NO: Rel - 203	**PRODUCT:** G3VM-351G – MOSFET Relay
DATE: February 2018	**TYPE:** DISCONTINUATION – Streamline Product Offering

G3VM-351G MOSFET Relay - DISCONTINUATION

**G3VM-351G Suggested Replacement -- Differences from discontinued product:**

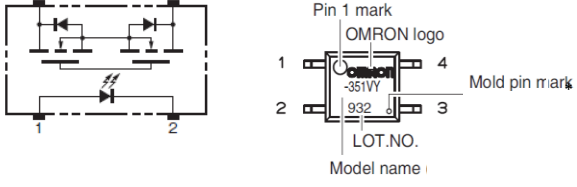
Suggested replacement Model	Body Color	Dimen -sions	Wire connection	Mounting Dimensions	Charact -eristics	Operation ratings	Operation methods
G3VM-351VY	- -	*	**	**	*	*	**
G3VM-351VY(TR) G3VM-351VY(TR05)	- -	*	**	**	*	*	**

** : Compatible
*   : The change is a little/Almost compatible
-- : Not compatible
-   : No corresponding specification

Dimensions:

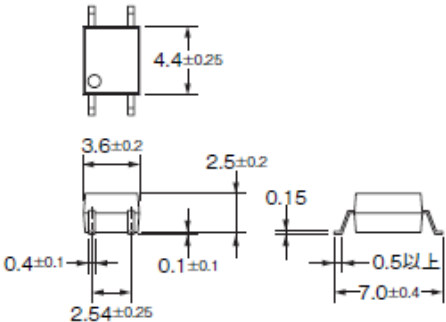
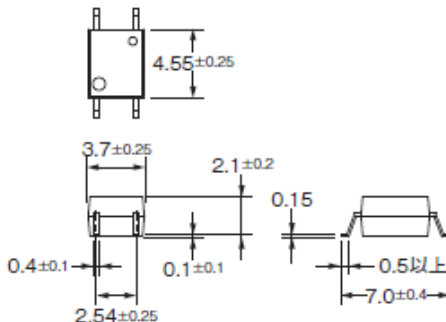
Discontinued Model G3VM-351G / 351G(TR)	Suggested Replacement Model G3VM-351VY / 351VY(TR) / 351VY(TR05)
Package type: SOP4 Surface mounting Terminal	Package type: SOP4 Surface mounting Terminal
